EN Adding Zeolite fill tube shields

US built Bosch dishwashers with "Crystal Dry" zeolite drying built through FD 0301.
Dishwashers built FD 0302 or later are not affected.

Fill tube shield material #: 10027073

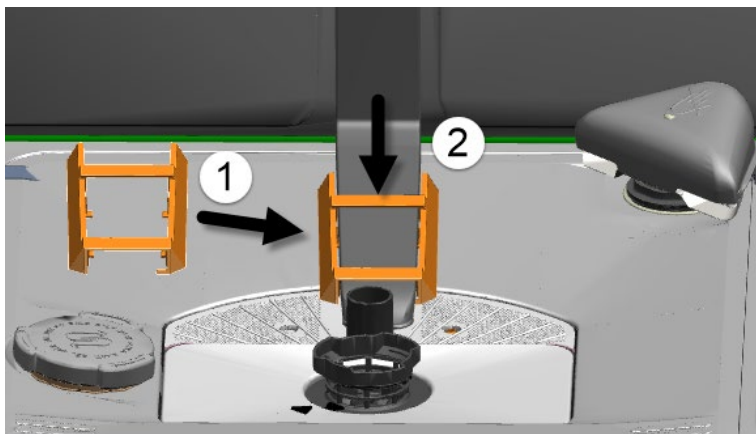
Some fill tubes that deliver water to the middle and top rack can develop cracks, holes, or split seams over time. To prevent this deterioration, a cover shield was added starting FD 0302 to all zeolite models.

Perform fill tube shield preventative repair – install fill tube shield # 10027073 onto the fill tube whenever any unrelated repair is done on an affected unit.

1. Open door and remove all racks. If needed for access, rotate or remove lower spray arm.
2. Align the fill tube shield over the fill tube with the wider open end toward the rear of the tub (1) and push it down to snap it into place onto the fill tube (2).
